Addendum No.: 7

Date Of Addendum: 3/15/19

York Correctional Institution Central Plant and Piping Distribution

PRE-BID QUESTIONS AND ANSWERS (CUMULATIVE) – ADDENDUM 7

B3042T - Bar Joist Hanger

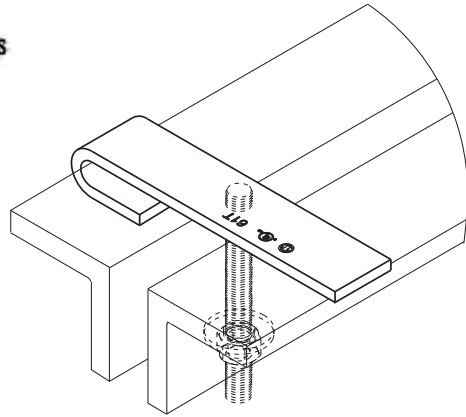
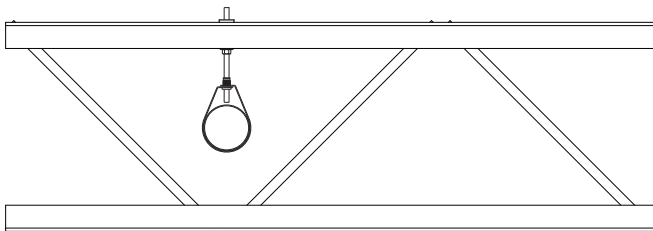
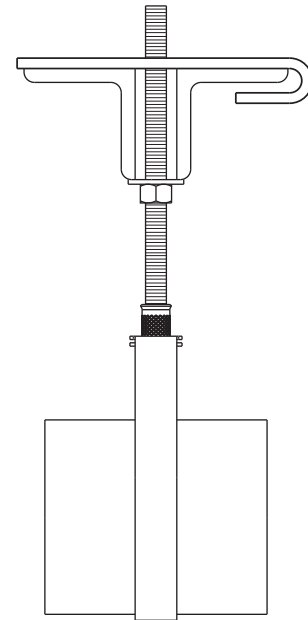
- **Q280: (5A) Typical Joist Hanger Detail on Drawing S003 does not clearly show what the joist hanger attachment to the top chord is. Please describe what this typical joist hanger attachment actually is.**

See attached for responses to pre-bid questions Q266 thru Q288 with typical bar joist hanger attachment cutsheets provided for reference (A280).
